MIDLAND NUCLEAR PLANT -  
UNIT NO. 1, DOCKET NO. 50-329  
UNIT NO. 2, DOCKET NO. 50-330  
SEISMIC CABLE TRAY SUPPORTS

QUALITY ASSURANCE PROGRAM  
MANAGEMENT CORRECTIVE ACTION REPORT  
MCAR-1

Cable tray support construction welding discrepancy

PROJECT: Consumers Power Company Midland Plant Units 1 & 2 Bechtel Job  
7220

FIG. 1 TYPICAL UPPER & LOWER SUPPORT COLUMN CONNECTION.

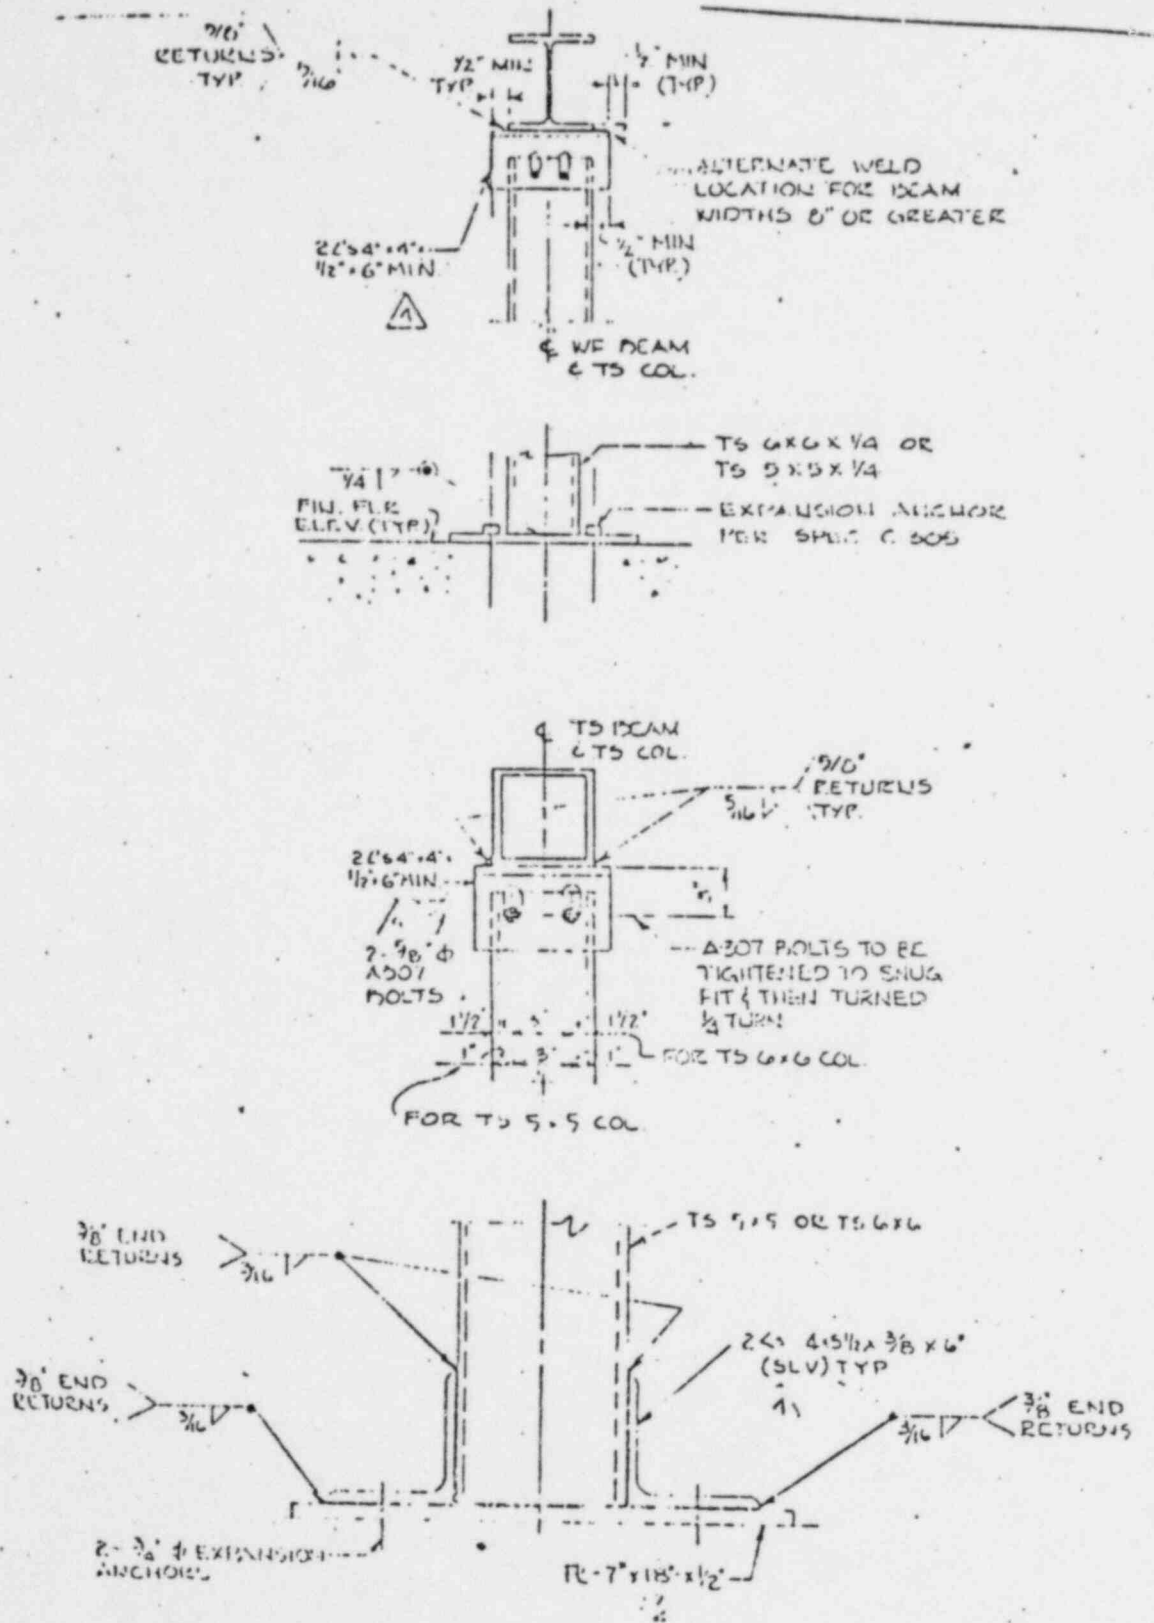
There are four groups of typical connectons reported in the NCR 1287 and NCR 1306 as shown in Figures 1 through 4.

Evaluation of the undersized weld is performed by examining the maximum load-carrying capacity of an undersized weld connection to the minimum required load-carrying capacity from structural analysis of the support system. End returns are in general not considered in the design evaluation.

Engineering's evaluation has concluded that both the undersized and oversized welds reported in both NCRs meet design requirements and project design criteria and is not a significant deviation from performance specification. (See CPCo Note 1)

However, for the undersized welds, the minimum weld size required by AISC code was not accomplished and the oversized welds exceeded Specification 7220-C-304 Rev 3 requirements. Engineering is presently evaluating code and specification deviation cases as well as any possible adverse effect to the weld strength.
